APPLICATION FOR DRIVEWAY CUTS AND OPENINGS

CITY OF CAMBRIDGE

Address of proposed curb cut or off-street parking facility: <u>271-273 WASHINGTON ST.</u>	
Frontage: <u>71.0 FT.</u>	Block and Lot: _____
Setback (distance from building to sidewalk): <u>14.9 FT.</u>	
Distance from proposed driveway to surrounding structures and property line: <u>10'-10"</u> <u>7'-10"</u>	
Dimensions of proposed driveway: <u>14'-10" L x 15'-0 W.</u>	
Location of any trees, sign posts, fire hydrants, utility poles, etc., in direct vicinity of proposed driveway: _____

PLOT PLAN
271 - 273 WASHINGTON ST.
CAMBRIDGE, MASS.

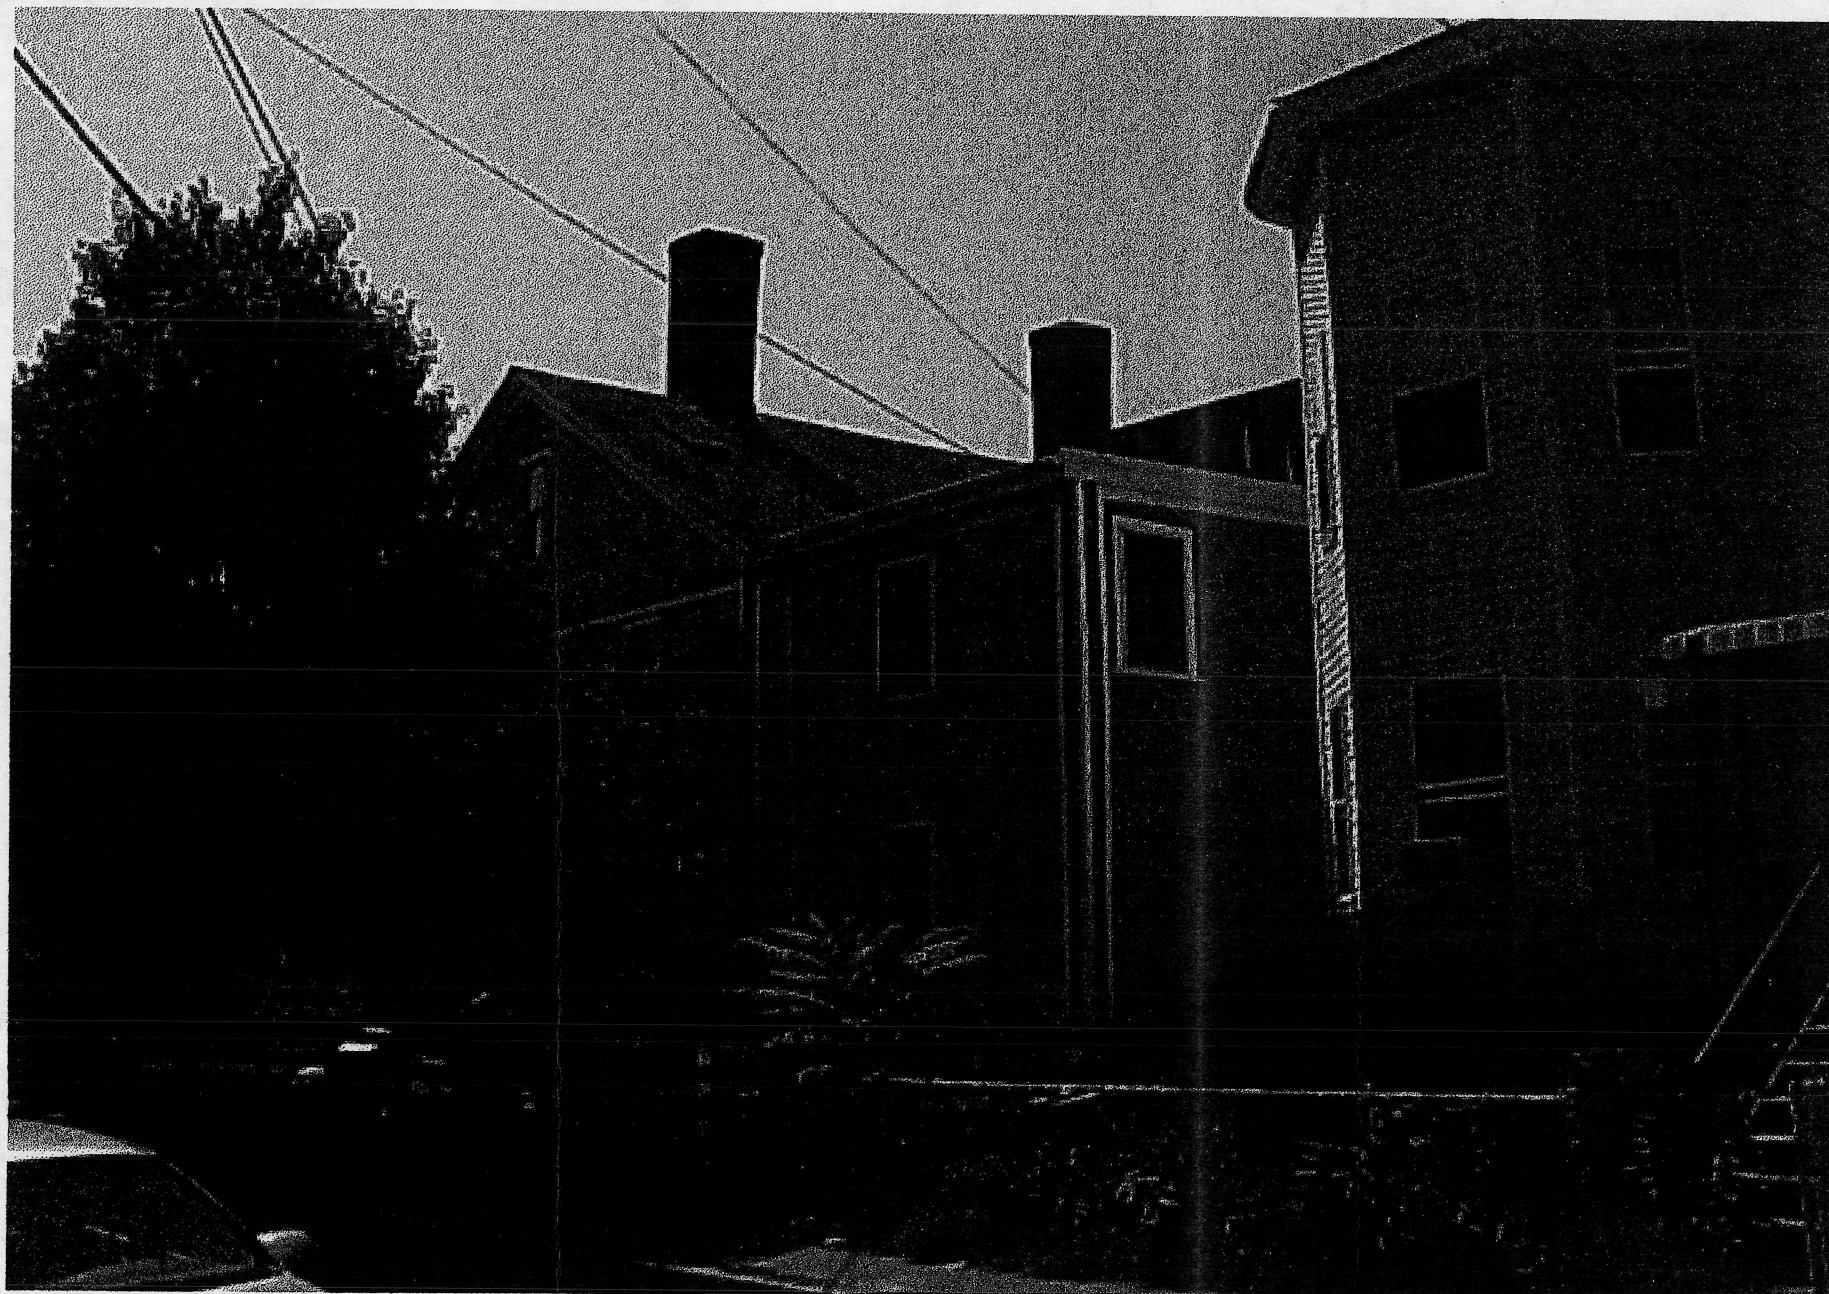
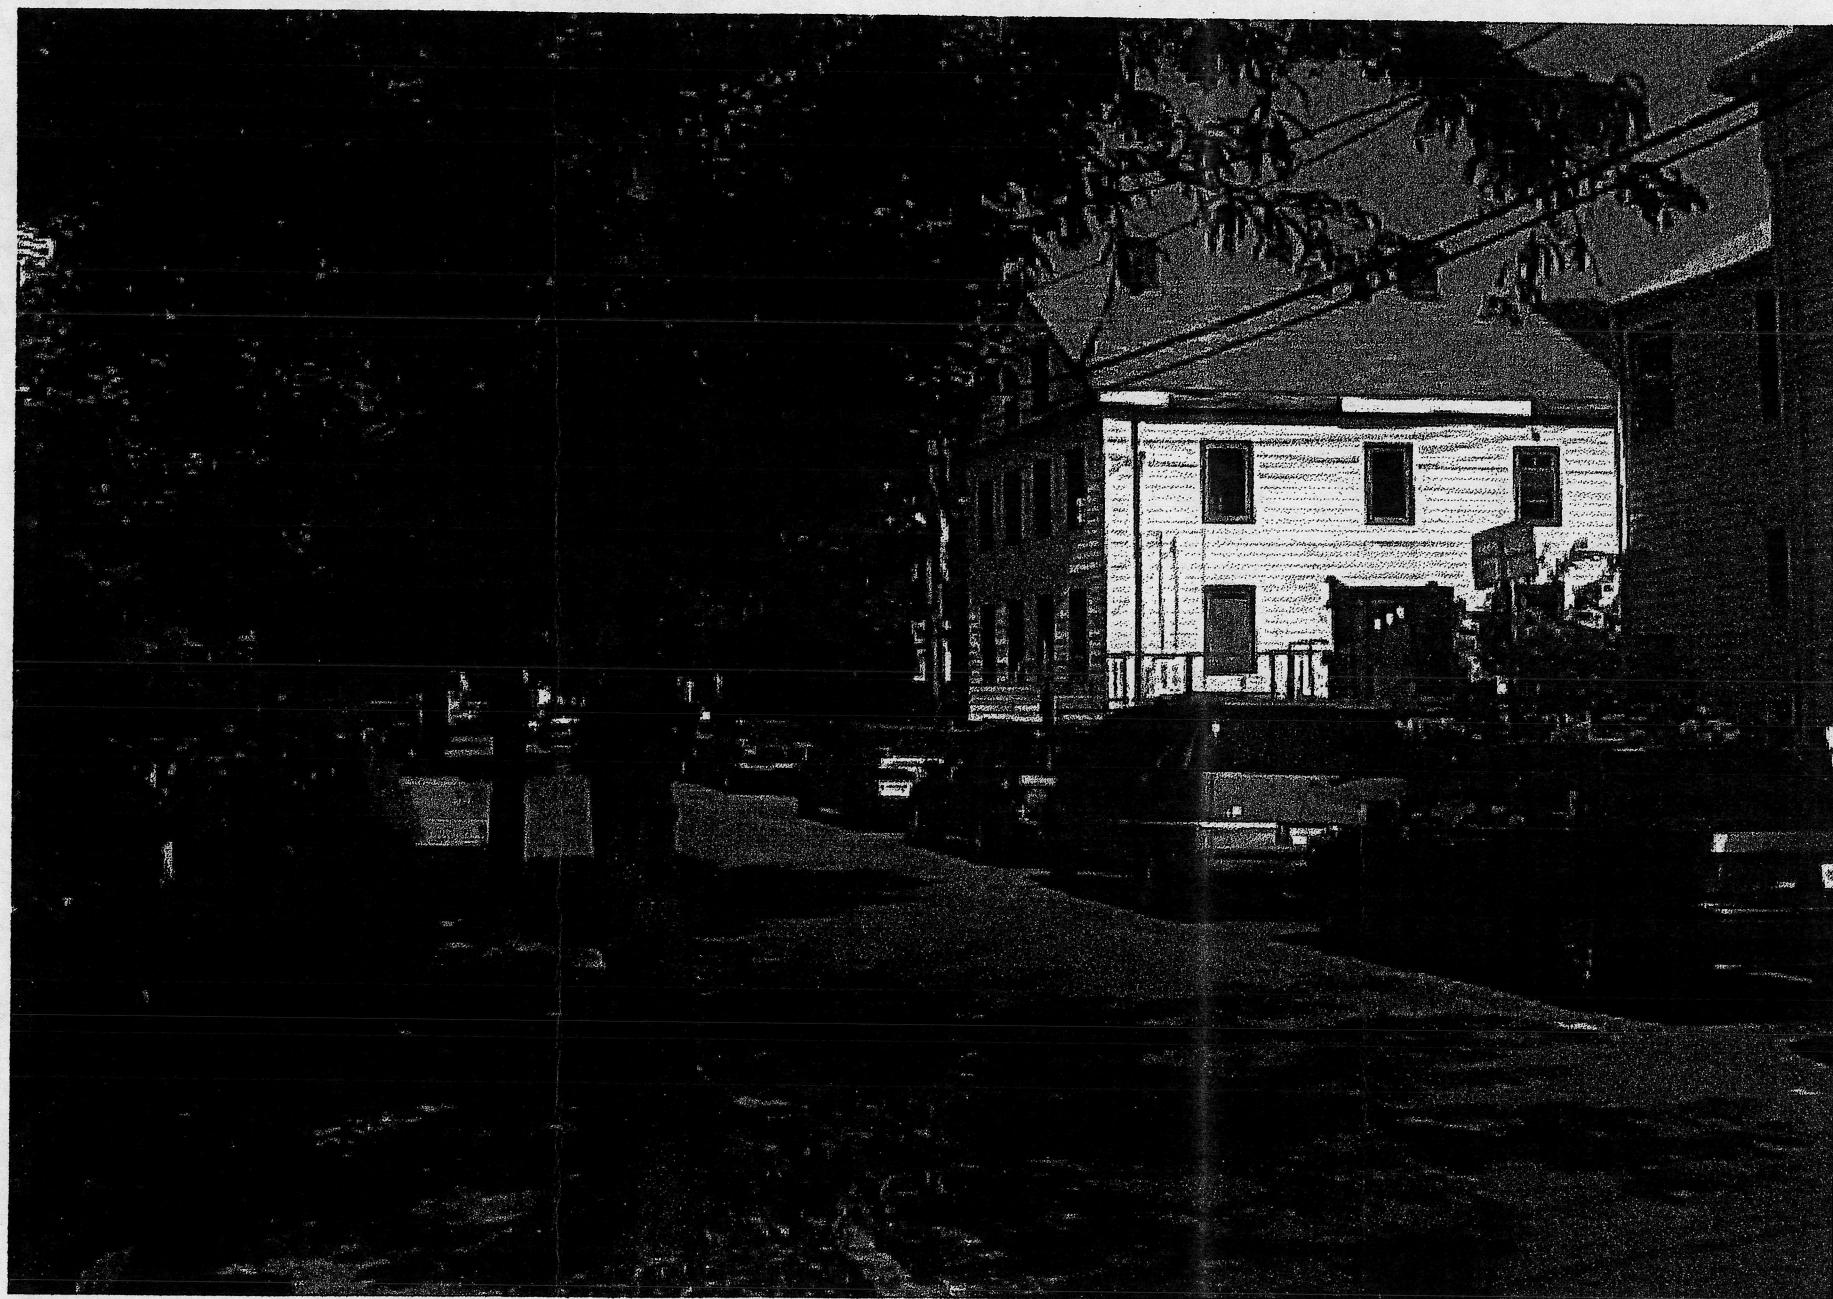
Reason: TREE REMOVAL IS NECESSARY FOR Tree removal. Catch basin must be relocated. All construction work must be the responsibility of Applicant.

UNDERGROUND PARKING
PARTIAL SECTIONS A-A & B-B
SCALE : 3/16" = 1Ft.
DATE : SEPT. 4, 2002

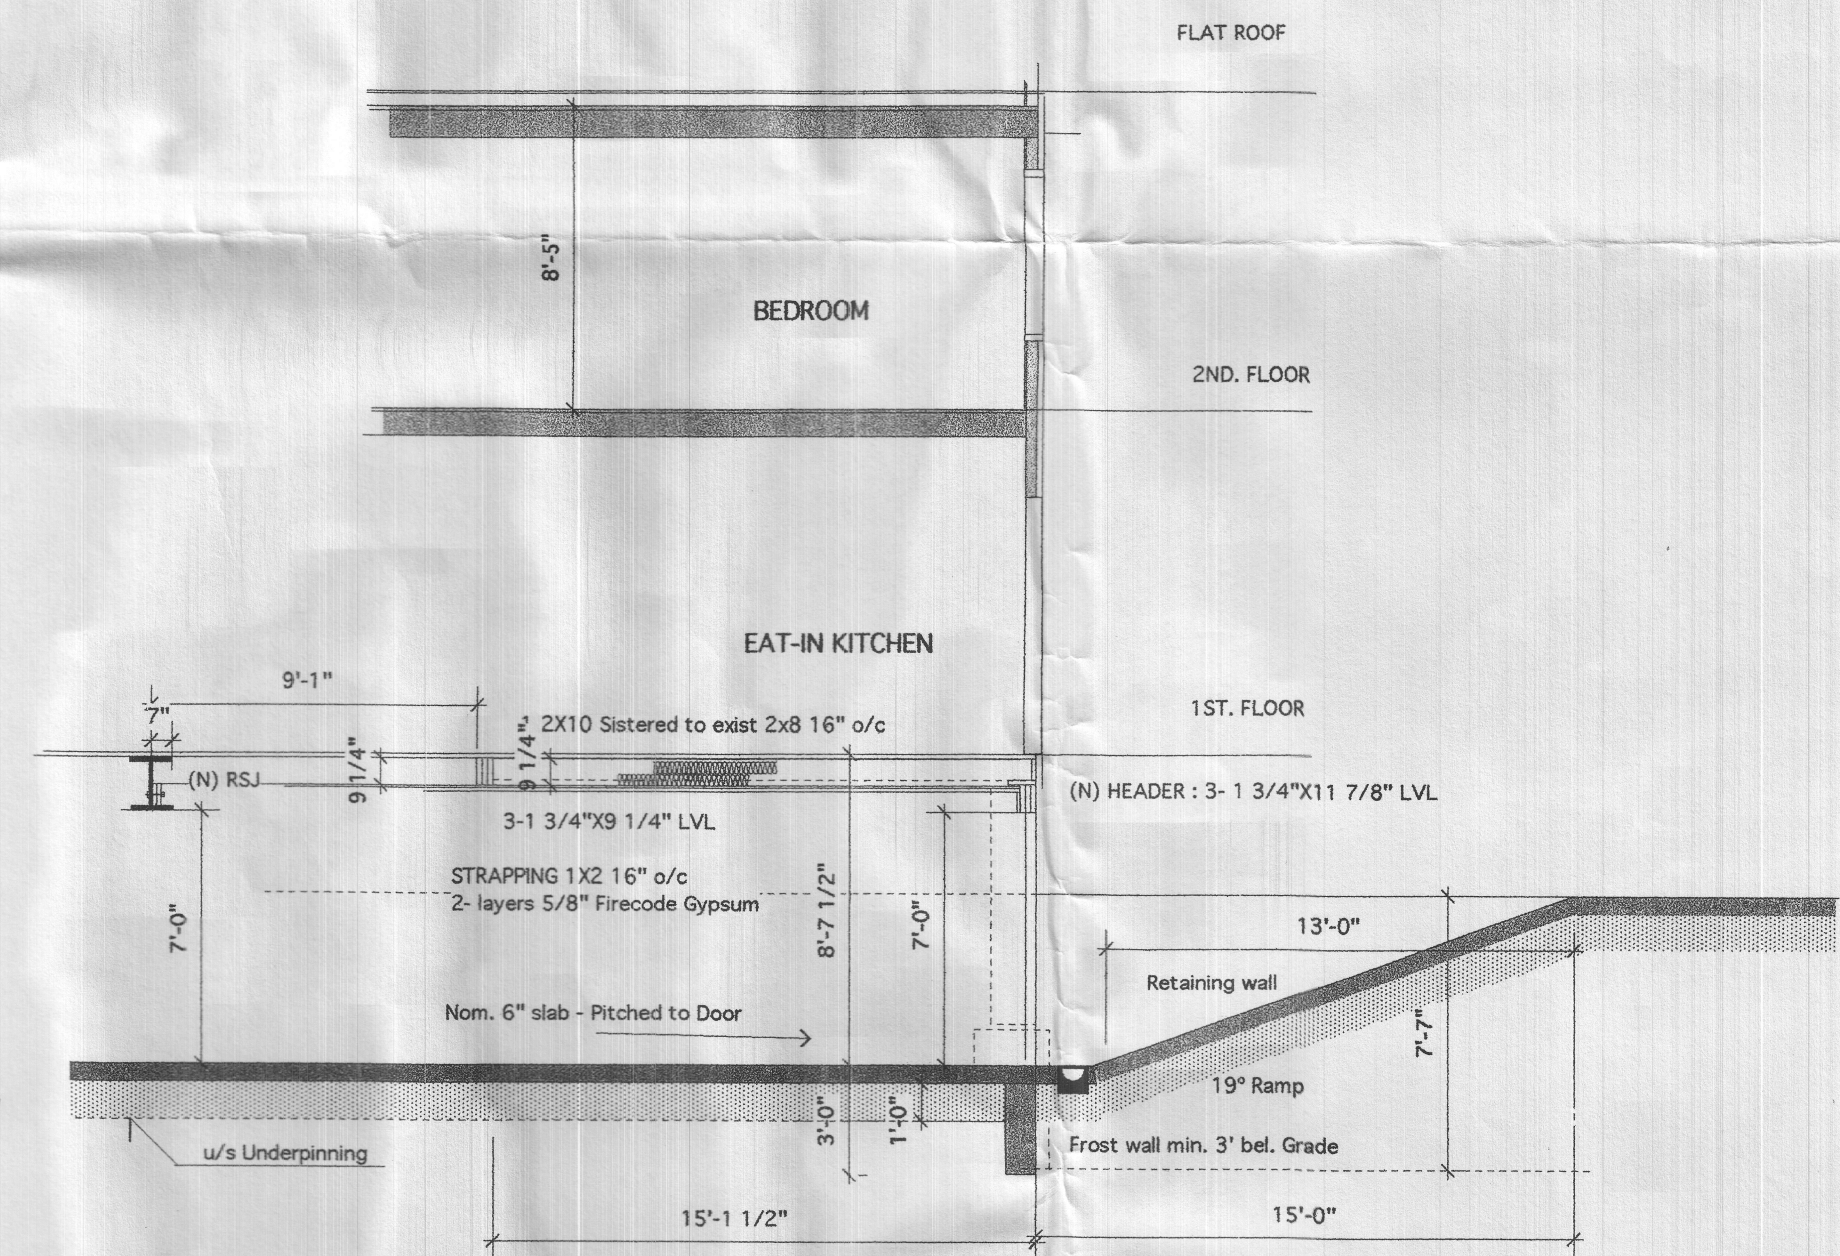
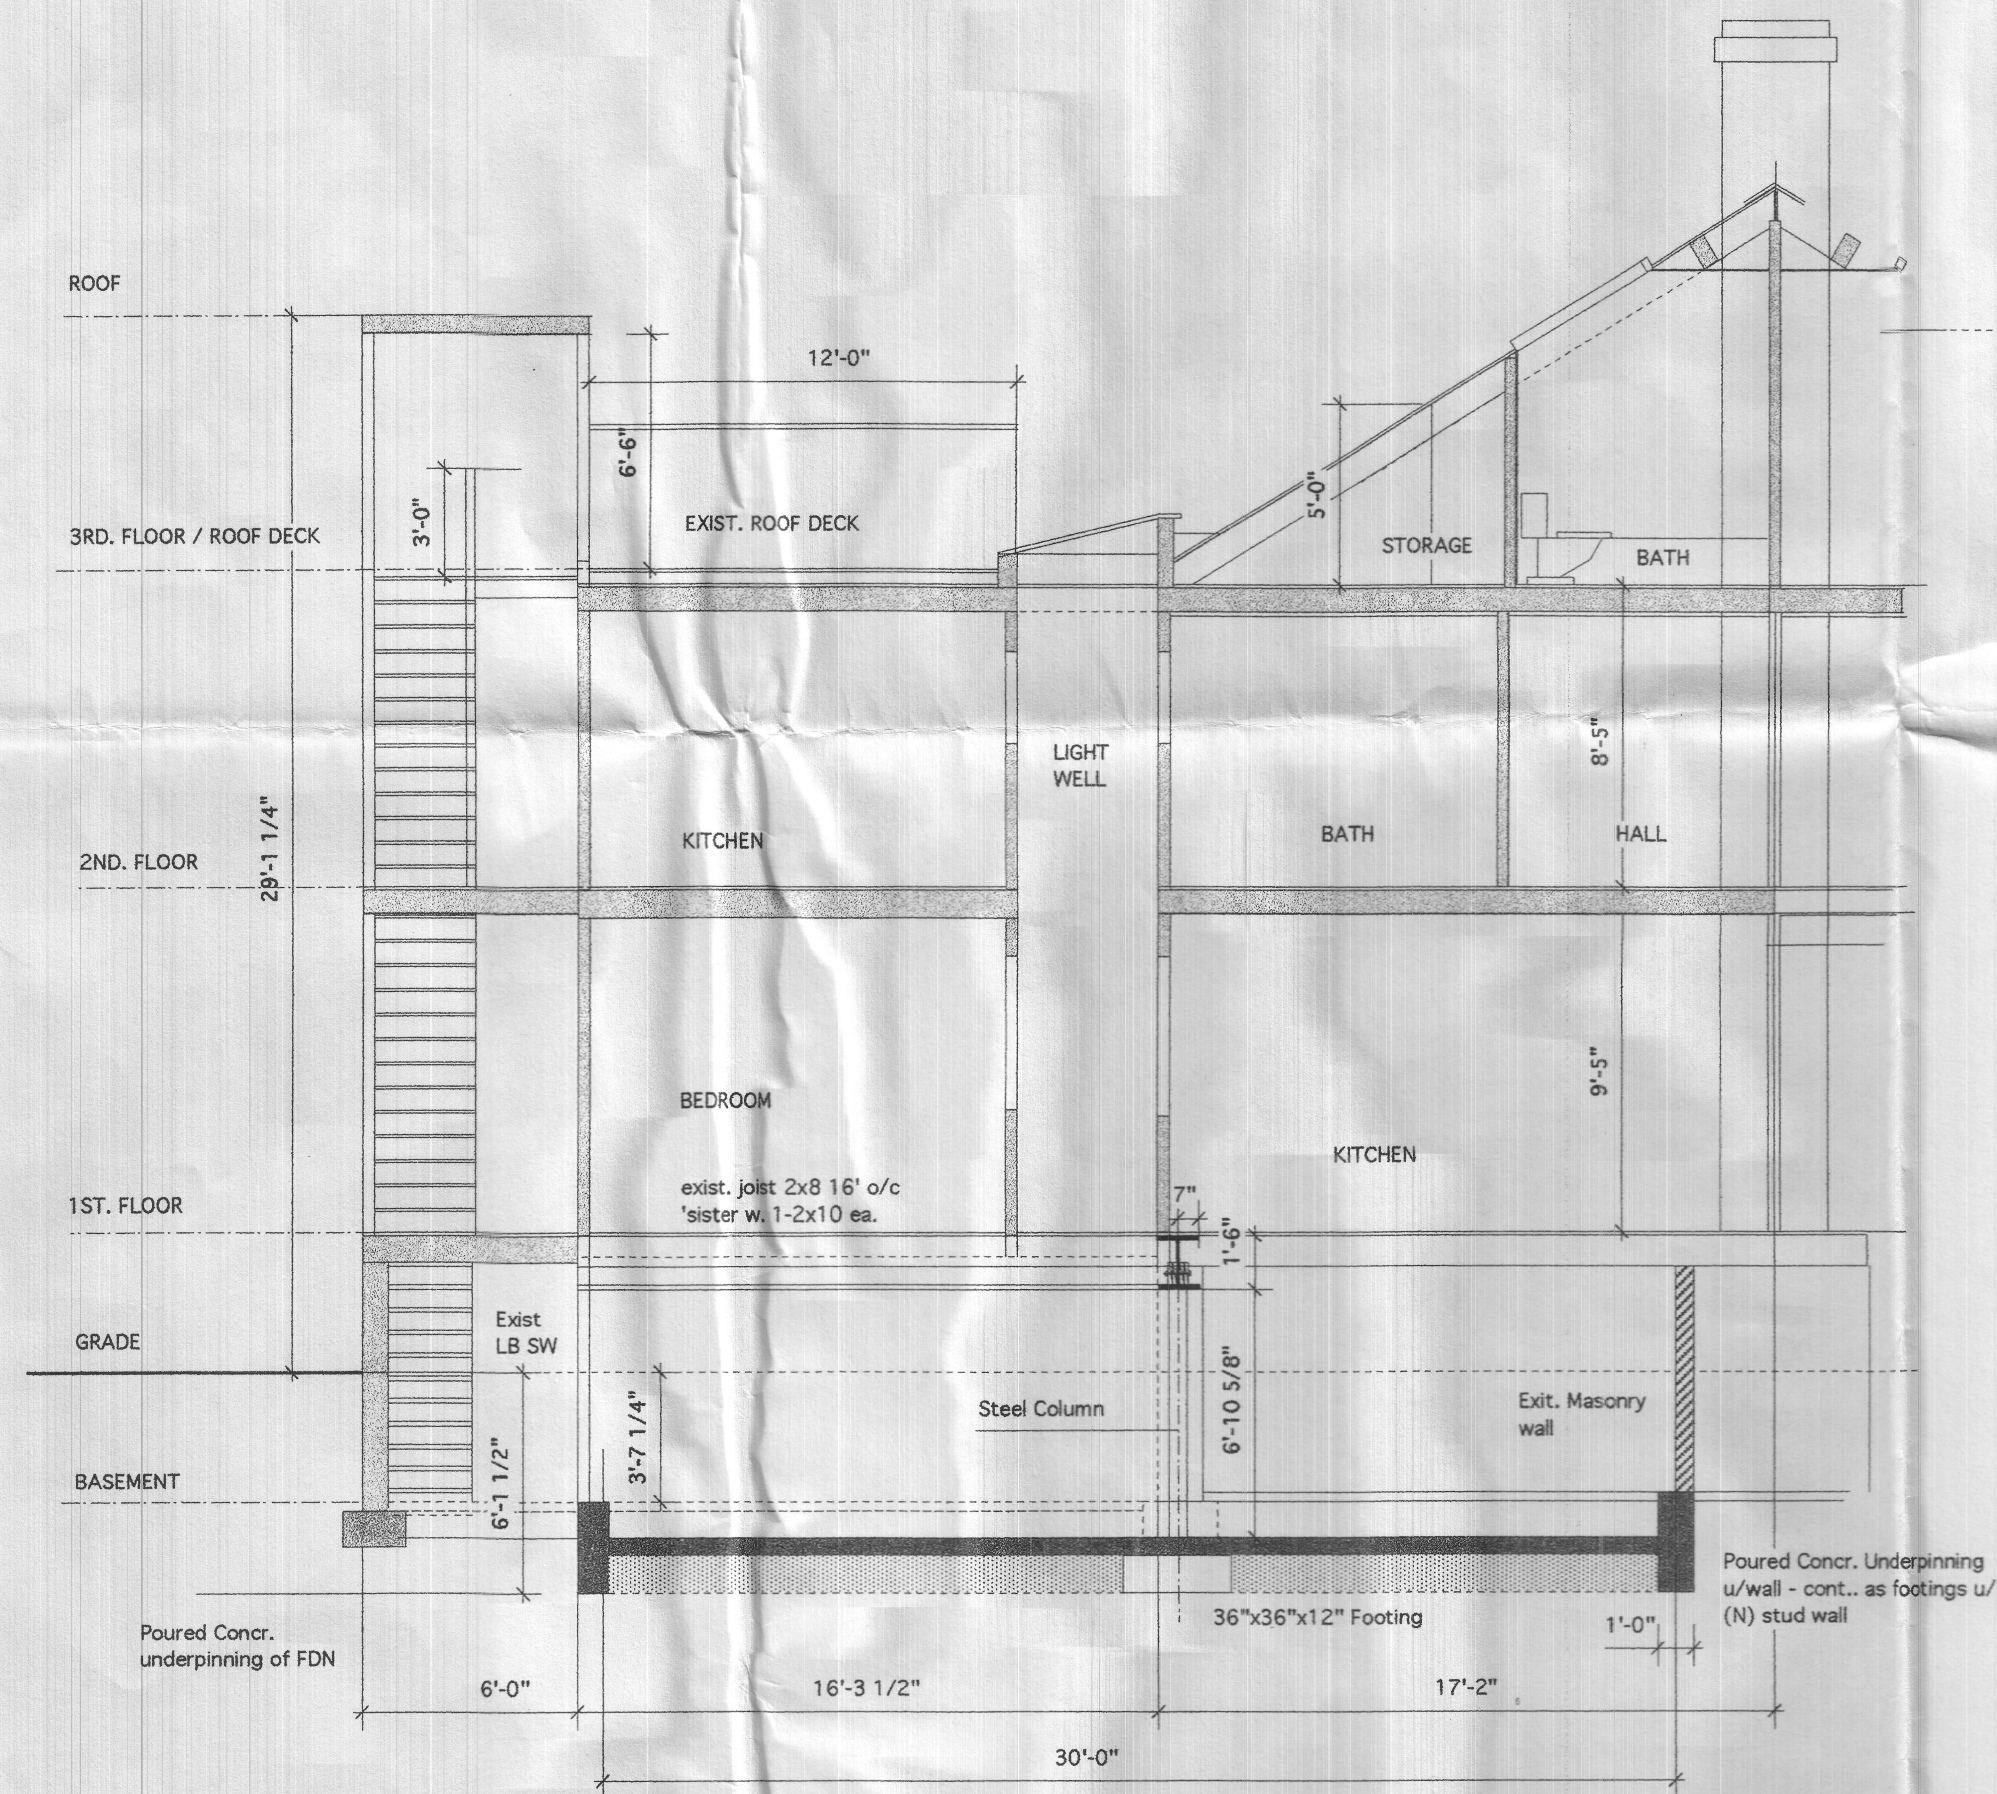
Reason: Driveway slope is too steep (19° or 34%)

Signature: Must be less than 8% within 15 ft. of SW Date: 11-14-02

Title: [Signature] Traffic Engineer OK plan resubmitted with 8% ramp JRP 5-26-03
